Subject: MHI's Responses to US-APWR DCD RAI No. 81-1253 Revision 0

Responses to Request for Additional Information
No.81-1253 Revision 0

US-APWR Design Certification

RAI NO.: NO.81-1253 REVISION 0
SRP SECTION: 19 – Probabilistic Risk Assessment and Severe Accident Evaluation
APPLICATION SECTION: 19.1
DATE OF RAI ISSUE: 10/7/2008

Figure 19-121.1 High Head Injection System Simplified System Diagram

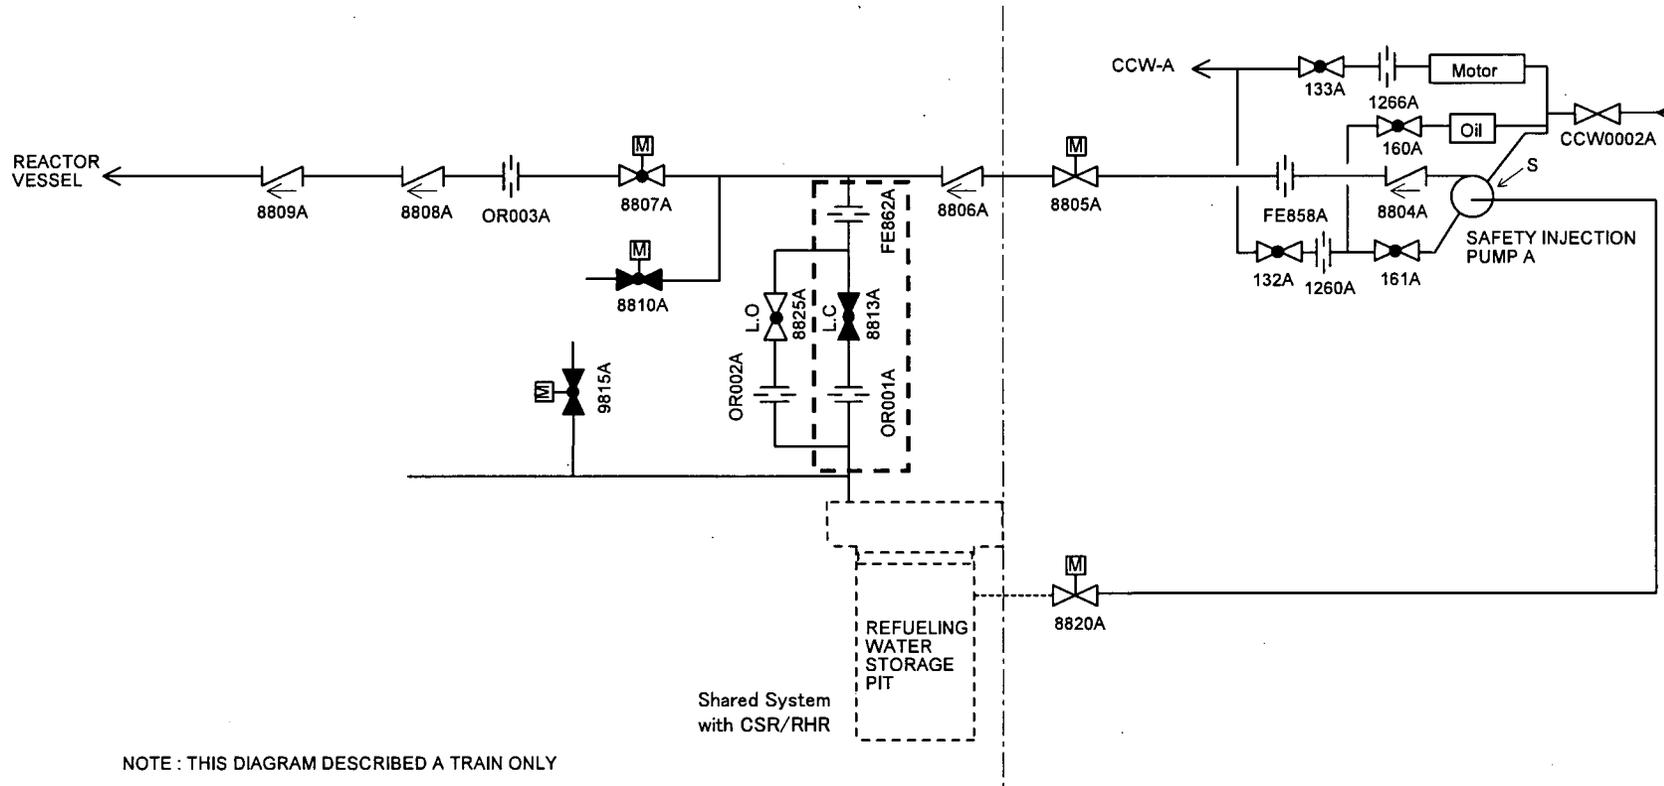
The event HPIPNELTSTCA (Table 6A.1-7) is described as "Piping non-service water system external leak L close side." Please clarify this description and explain what is meant by "non-service water system" (both in general terms and as it relates to the high head injection system (HHIS)).

The term "non-service water system" is used to indicate a system that is not the essential service water system. NUREG/CR-6928 "Industry-Average Performance for Components and Initiating Events at U.S. Commercial Nuclear Power Plants" provides two types of pipe failure rates, failure rates for the emergency service water (ESW) system and for non-ESW systems. Basic event HPIPNELTSTCA represents failure of piping in HHIS and the failure rate for non-ESW is applied to this event.

Basic Events HPIPNELTSTCA, B,C,D represent external leak event for the piping boxed in the bold dashed line in Figure 19-121.1. The values used to estimate the probability of the event are shown in Figure 19-121.1.
